Determination 2014/053

The compliance of a new commercial laboratory building without an accessible lift to the first floor, at 207 Gracefield Road, Gracefield, Lower Hutt

Figure 1: First floor plan, from applicant's submission (not to scale)

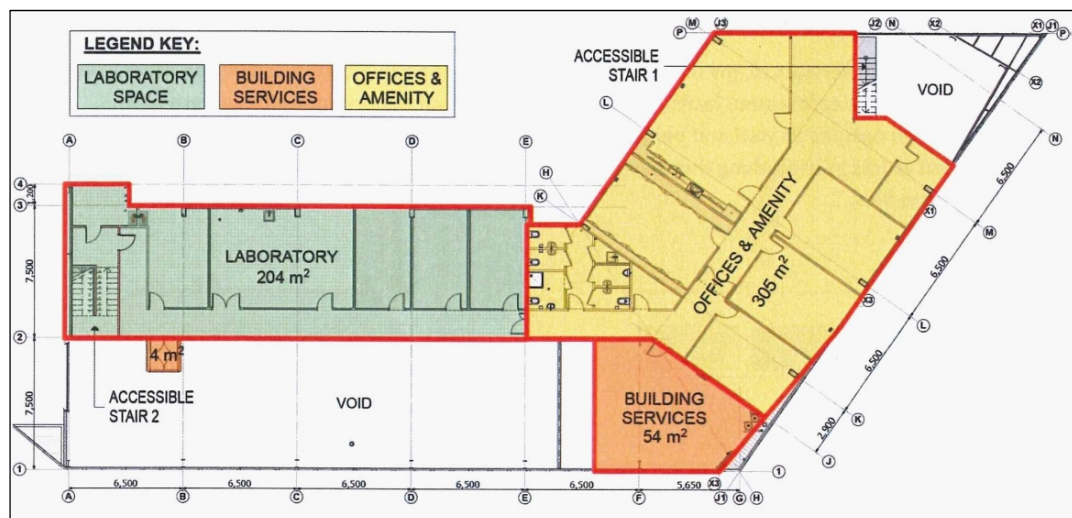
- The gross floor area is 567m², however a significant portion of the floor is dedicated to building services (58m²) and laboratories (204m²). The remaining 305m² is offices and amenities. (Refer figure 1 below)

- The building services area is allocated for building electrical and water services.
- The tenant will have four staff permanently stationed in the laboratory spaces on the first floor. The spaces are largely occupied by complex processing machinery, including incubators and custom building processing equipment; typically these are set in operation and monitored by computer process controls.

- The remaining offices and amenities area is expected to be accessed by 15 staff from the ground floor along with staff of the first floor (4 laboratory staff plus office staff).

- For the purposes of NZS 4121 and Clause D1, it is reasonable to assess the practical first floor area as being 305m² and alongside the declaration that only 22 staff in total will work in the building, a lift would not therefore not be required and the two accessible staircases are more than suitable to provide sufficient access to the first floor.

- 5.3.5 The designer has stated that the total intended occupancy of the building is 22 staff and that the laboratory rooms in the upper floor will be used by a total of 4 staff at any given time. This would reduce the calculated occupant load for the upper floor. However I am of the view the use of the lunch room by staff from the ground floor must still be taken into account, and accordingly the reduction of the occupancy of the upper floor laboratory area does not reduce the total below 40 persons.

- 5.3.9 Accordingly I conclude that the occupancy load of the upper floor is more than the 40 persons or more set out in D1.3.4(c)(iii), and therefore a lift is required in order to achieve compliance. I therefore consider that the proposed building without a lift to the upper floor does not comply with Clause D1.
